**MANASQUAN PLANNING BOARD MEETING AGENDA  
CONDUCTED WITH ZOOM  
OCTOBER 19, 2021 4:00 PM – TUESDAY**

Re: Boro File No. MSPB-R1670  
Site Plan – Main Street Station  
Block 88, Lot 39.01  
233 East Main Street  
B-1 - Business Zone  
Borough of Manasquan, Monmouth County, NJ

Re: Boro File No. MSPB-R1690  
Amended Site Plan – Manasquan VFW Lodge 1838  
Block 43, Lot 4.01  
30 Ridge Avenue  
R-2 - Residential Zone  
Borough of Manasquan, Monmouth County, NJ

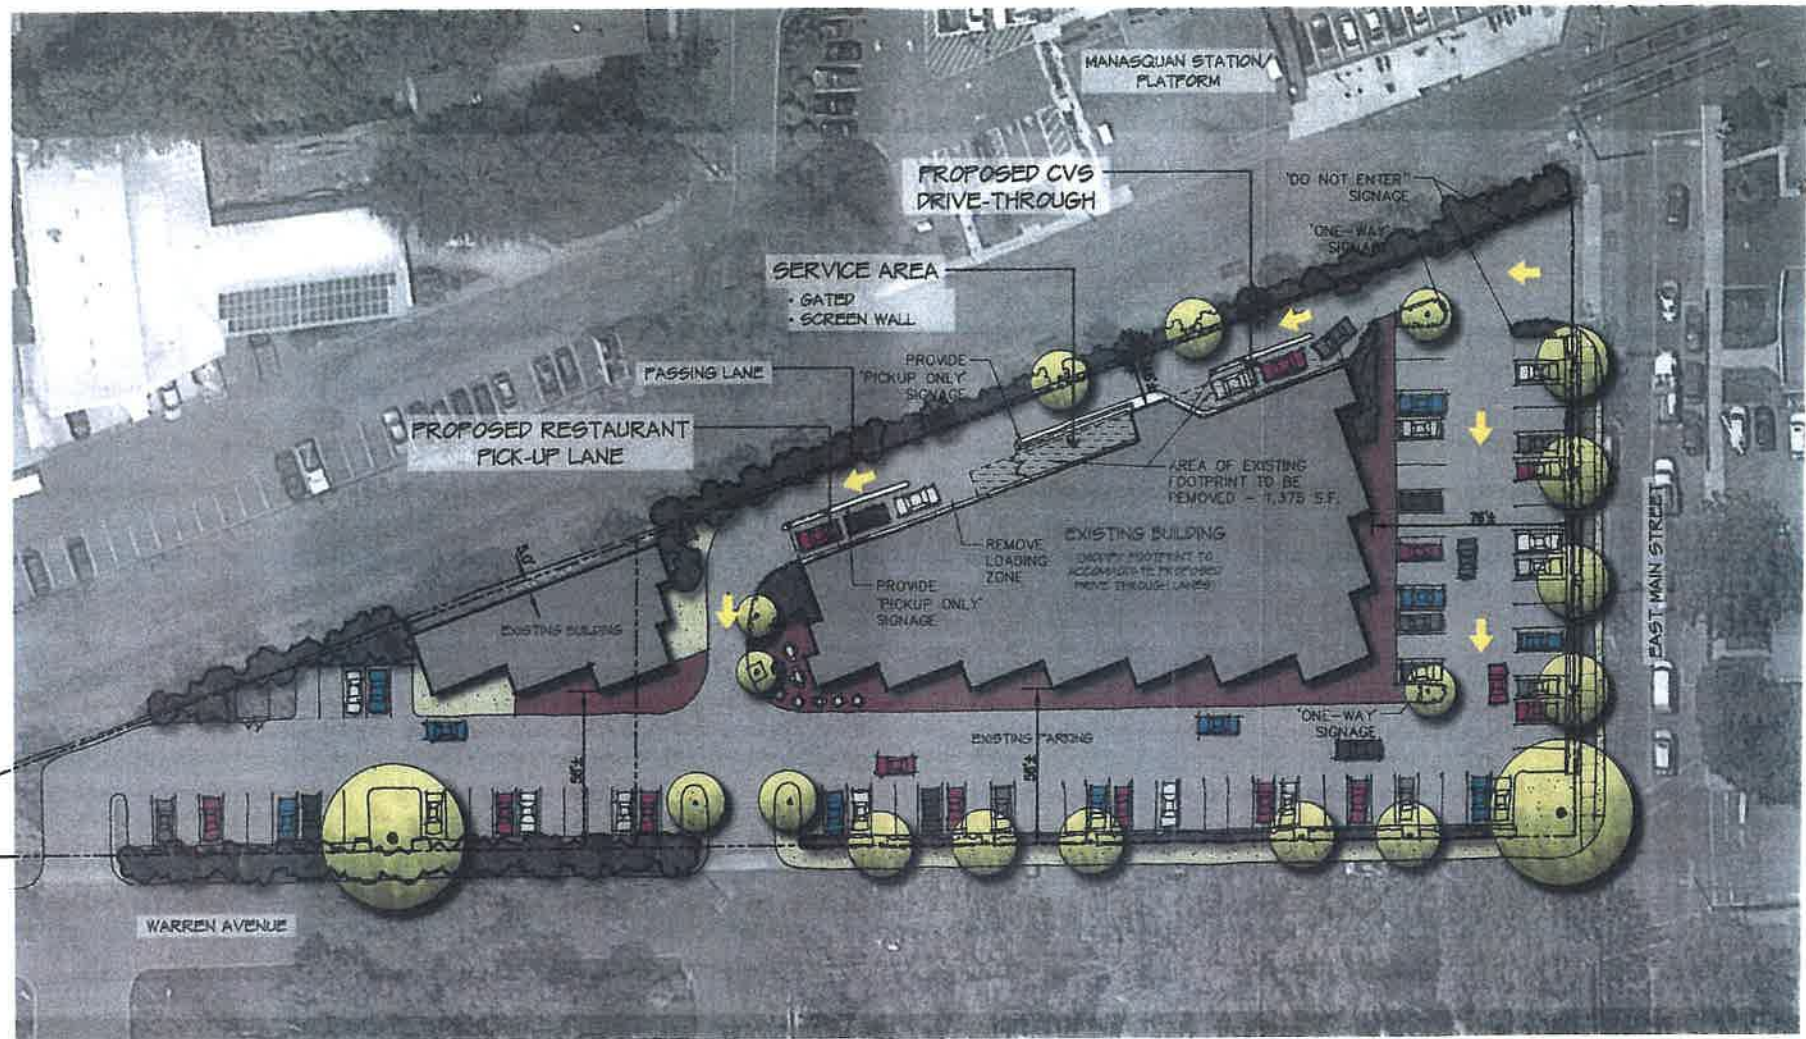
4. The applicant should explain the functioning of both of the proposed drive-through aisles, including; drop offs versus pick-ups, services offered (pharmacy pick-up, Covid testing, etc.), speaker/intercom systems including volume levels, and hours of operation.

5. Both drive up windows have limited stacking areas and appear to be able to accommodate three cars before they will impact the proposed passing lane. The applicant should explain how this will affect the site and traffic flow at the rear of the site. Stacking at the CVS window may also back out into the parking lot, near the entrance on East Main Street which must be considered.

6. The circulation parallel to East Main Street must be explained as if is to me limited to one-way traffic, cars travelling parallel to Warren Avenue towards East Main Street will be forced to turn around in the aisle if they do not find an available parking stall.

7. The applicant must explain the proposed “service area” between the two drive through areas. If it will function as the sole loading area, the nature of deliveries and their frequency, must be discussed.

8. The applicant should explain if the proposed improvements will add additional impervious coverage to the site. There are limited areas for additional stormwater management on site if they are necessary for additional impervious coverage.

**MANASQUAN V.F.W. PRELIMINARY & FINAL SITE PLAN**  
**AMENDED SITE PLAN**

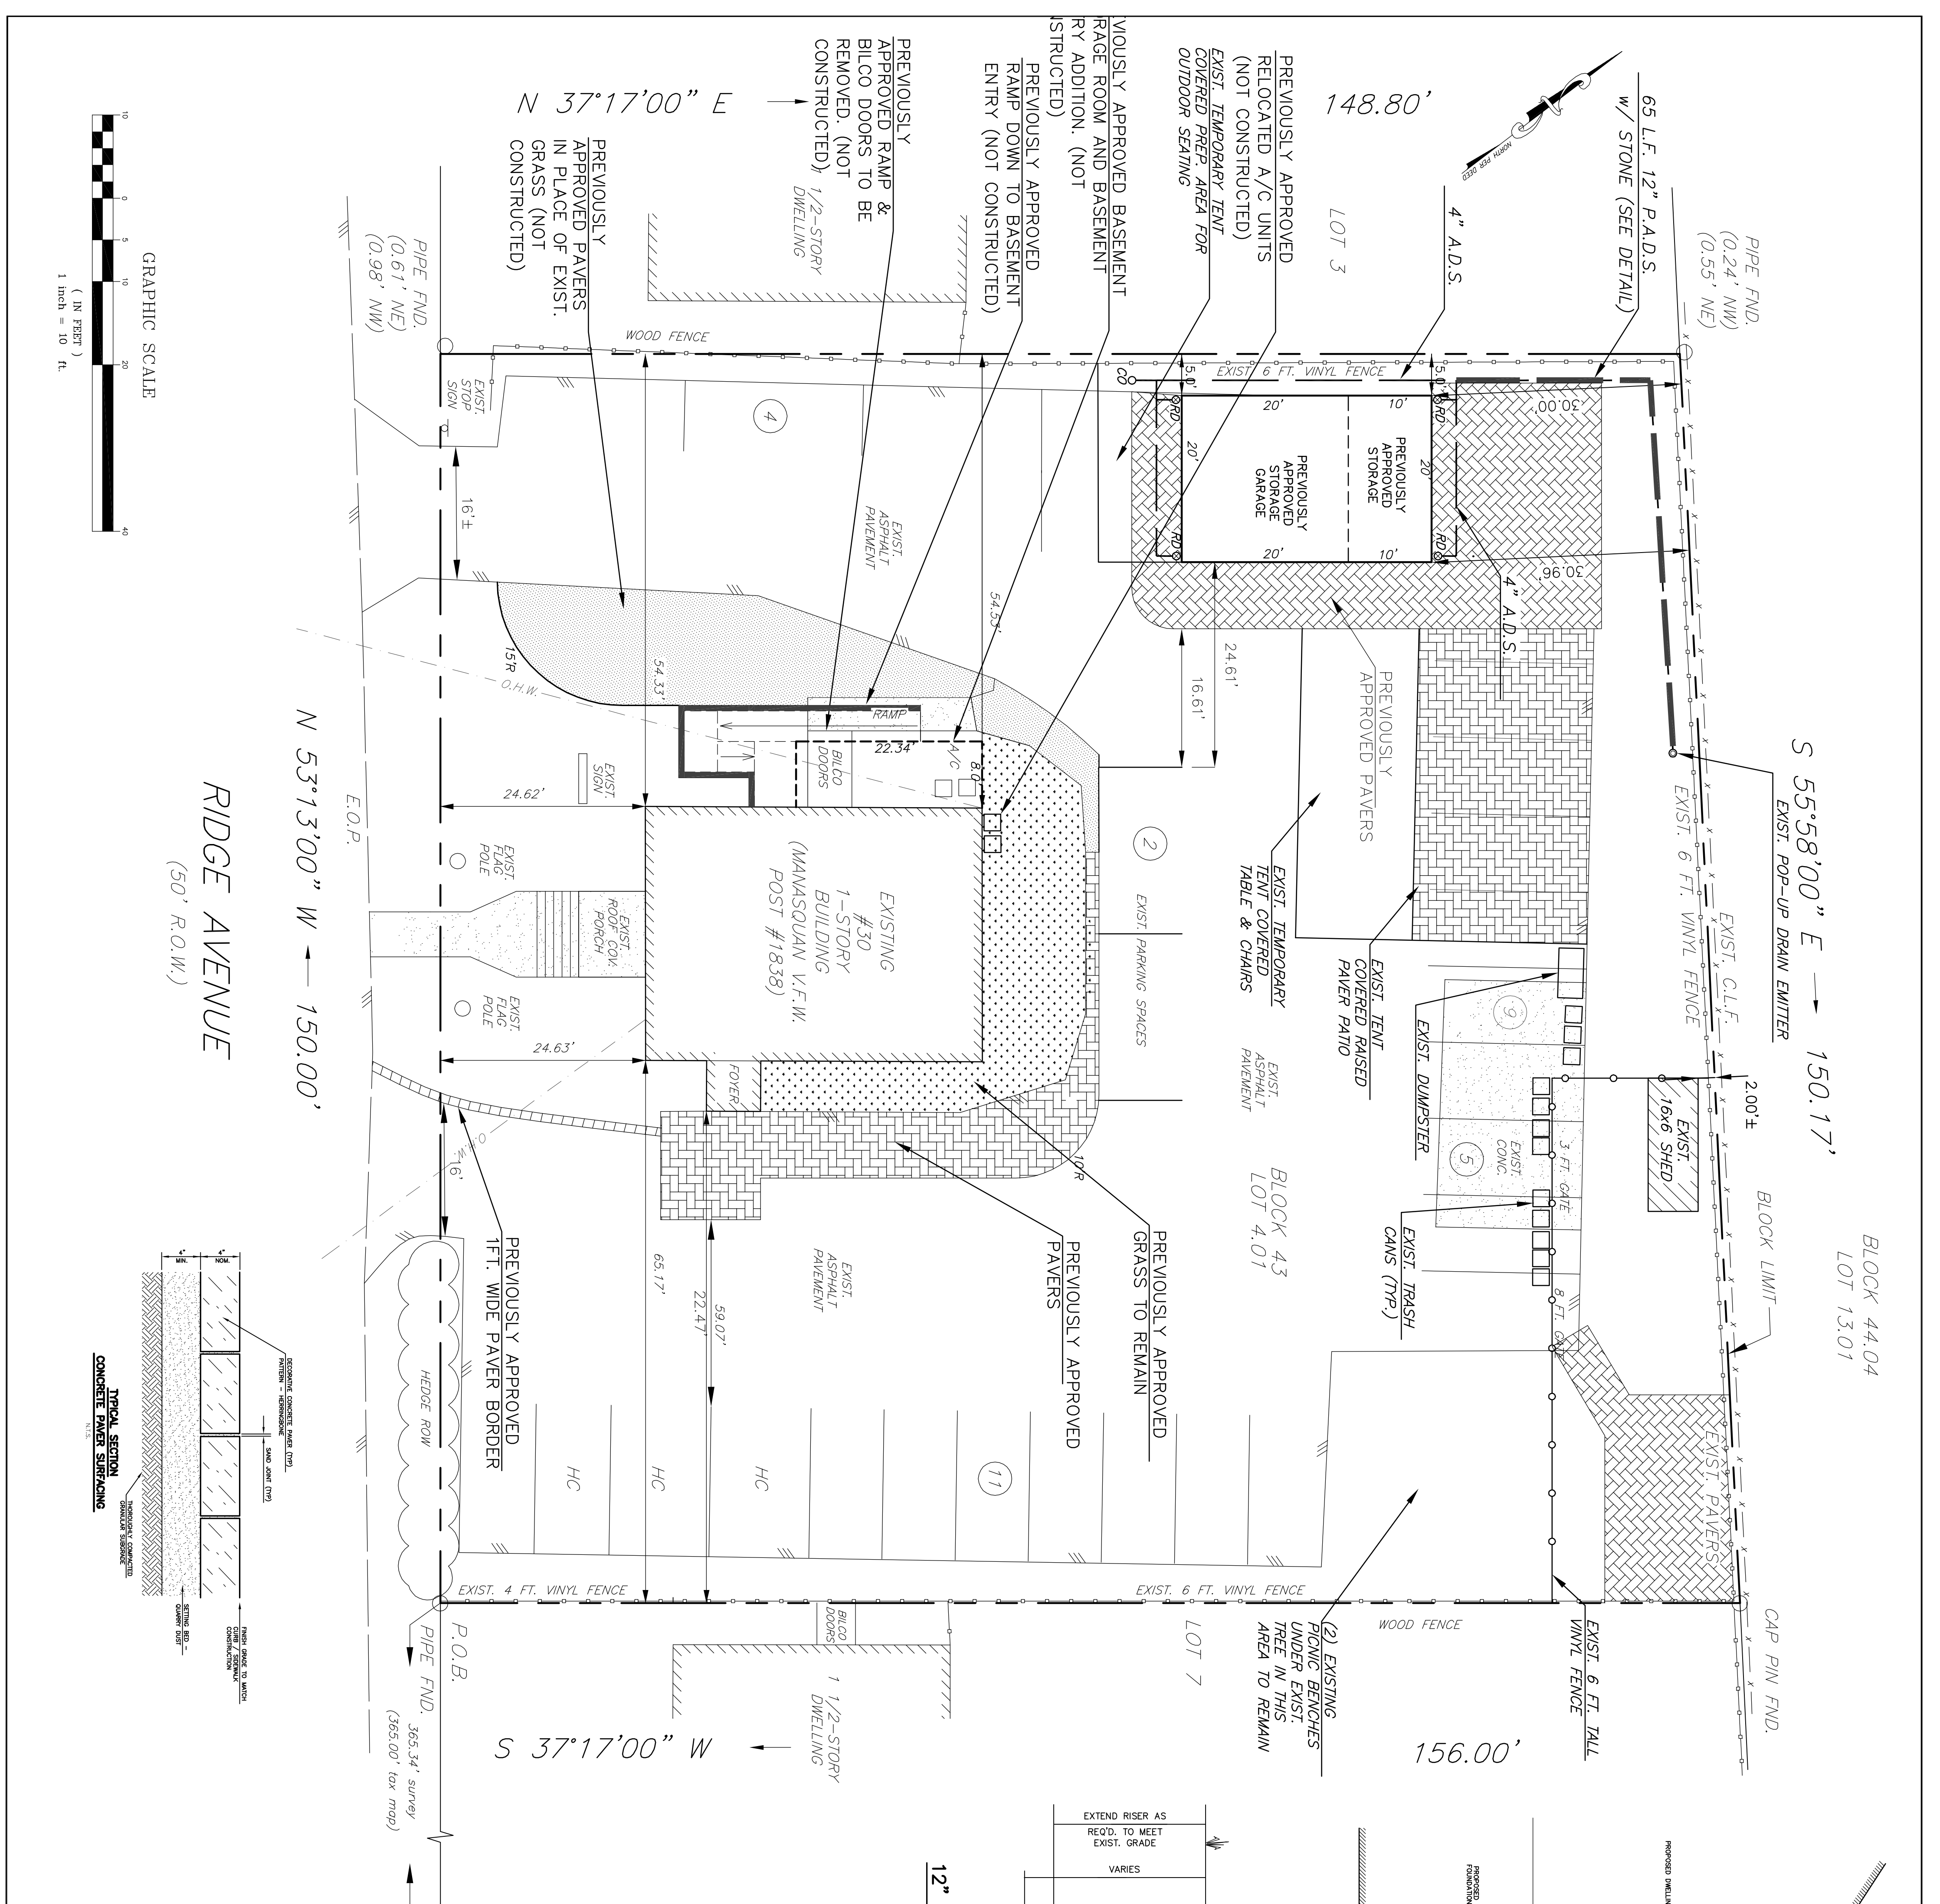
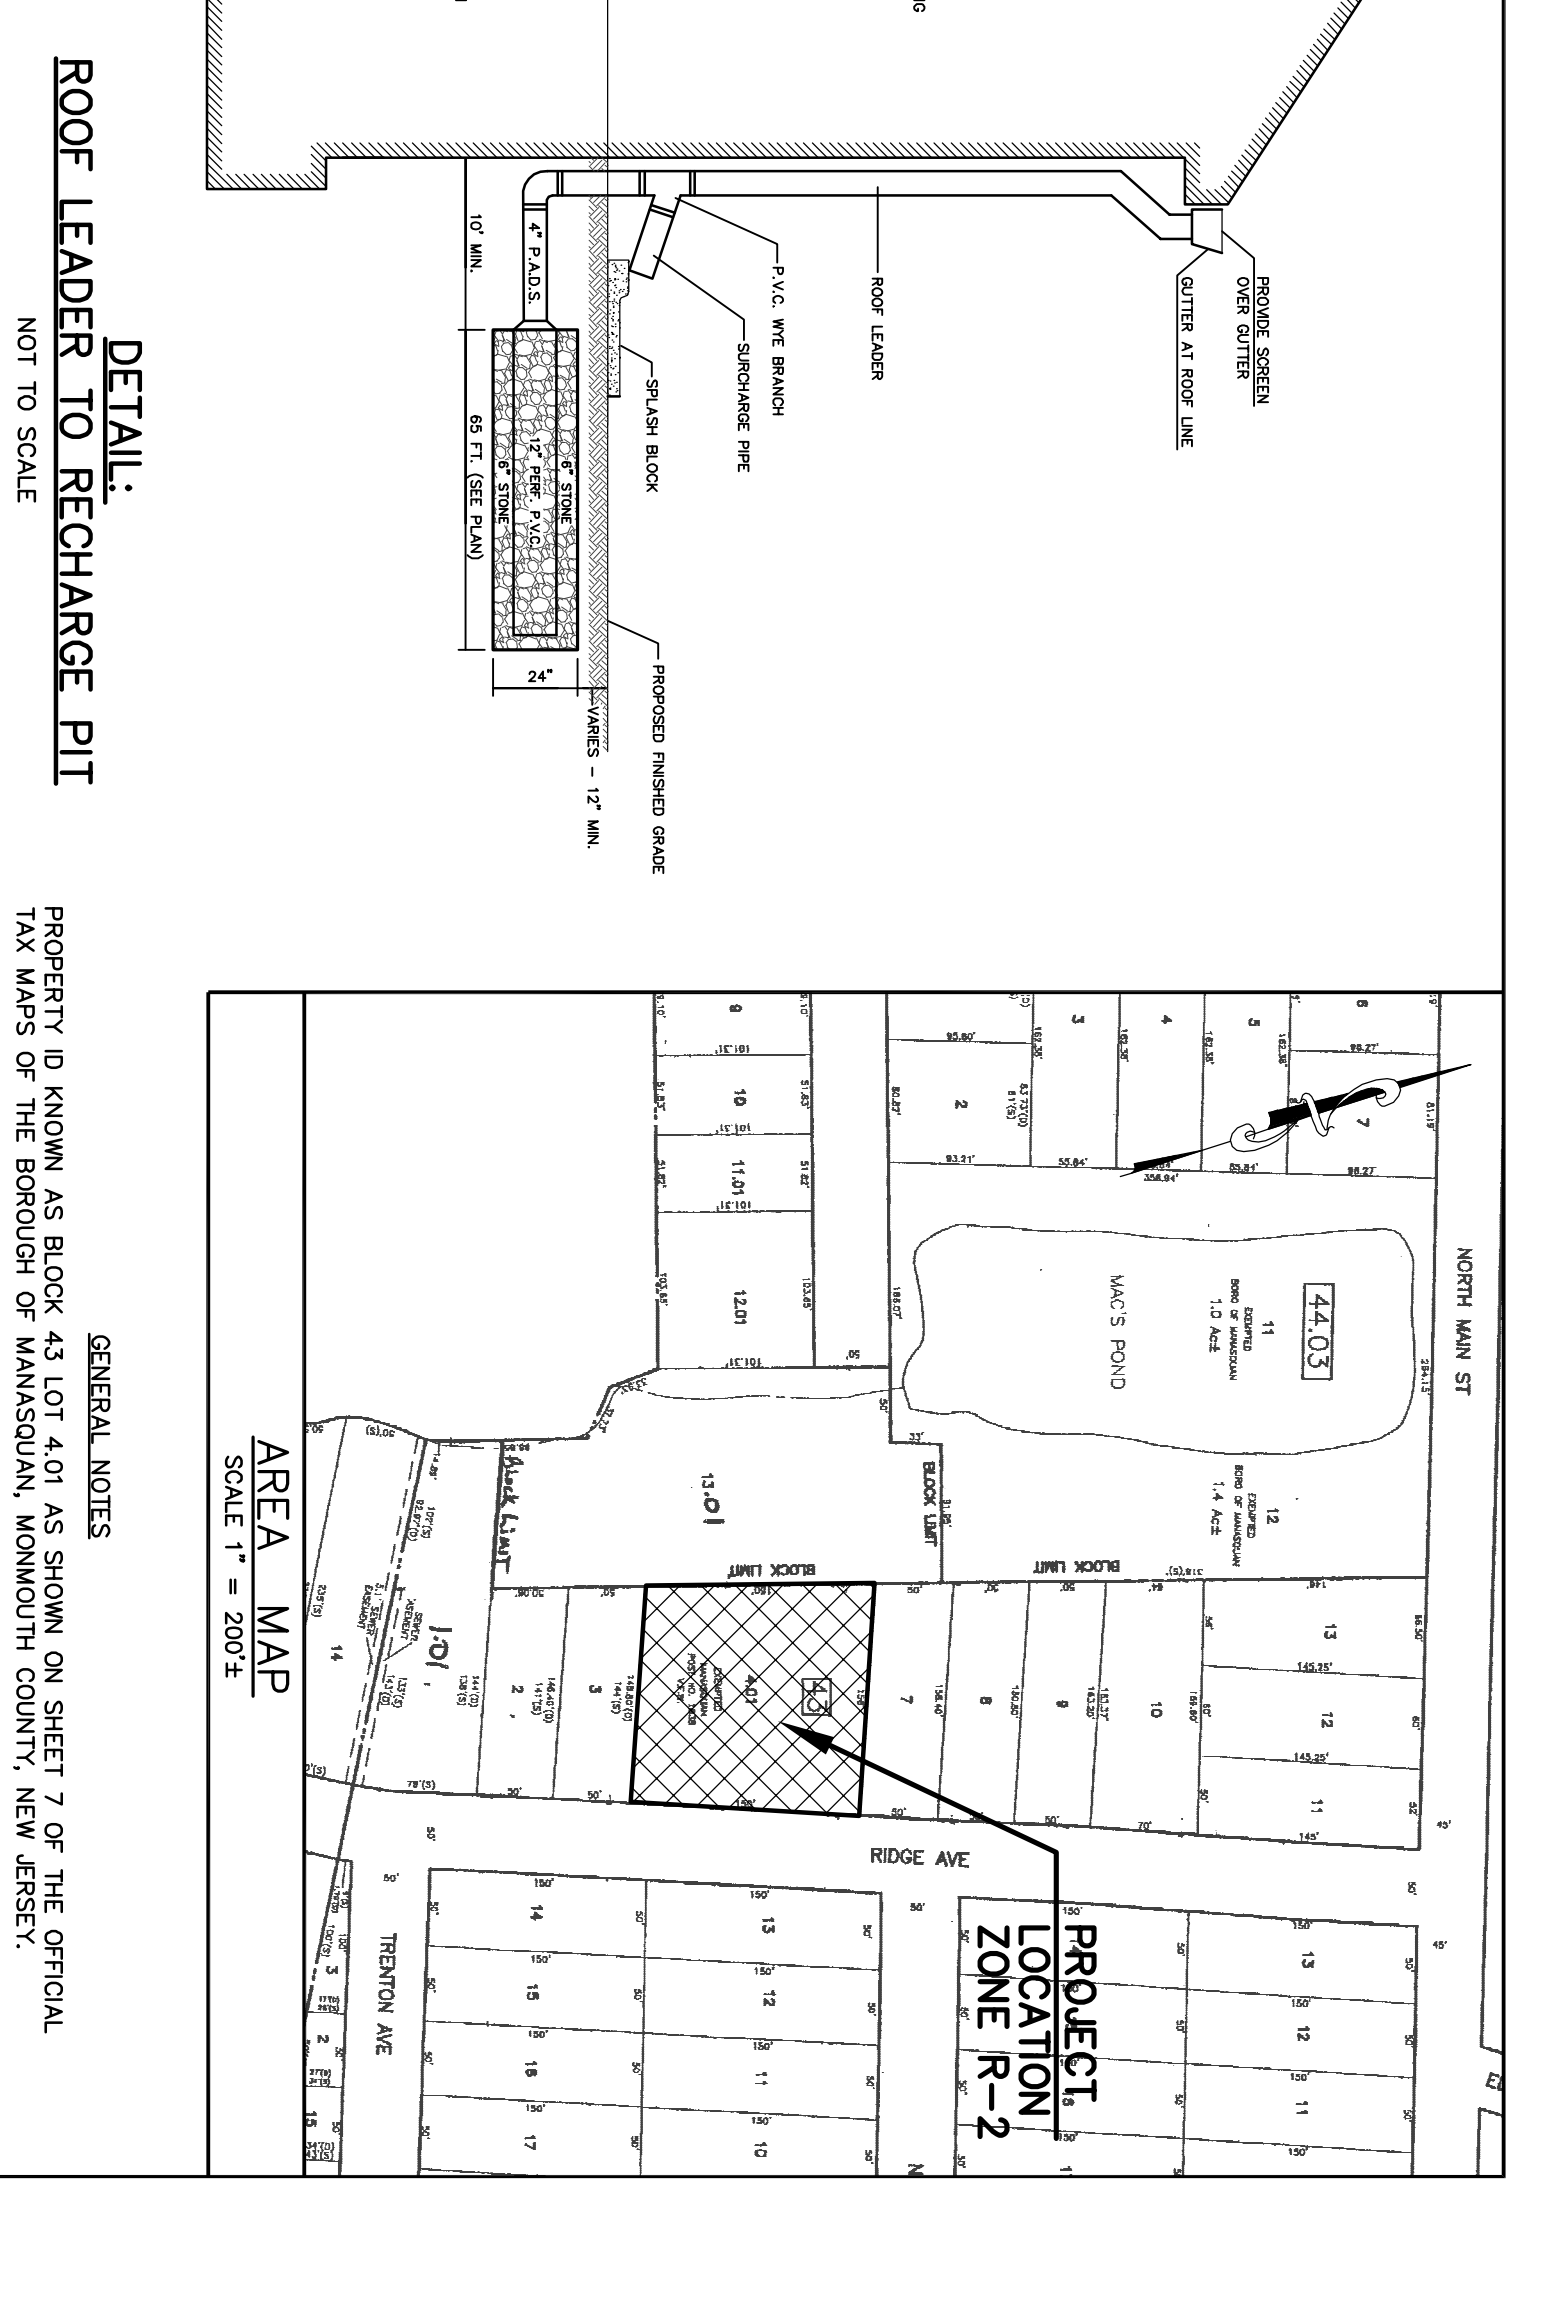
- c. One accessory building is permitted, whereas two accessory buildings exist and are proposed.
3. The following non-conformities exist on Lot 4.01 and are not proposed to be modified as part of this application:

6. Any outdoor lighting for the bar area should be shown and lighting levels indicated.
7. Any additional proposed signage should be shown on the plans.
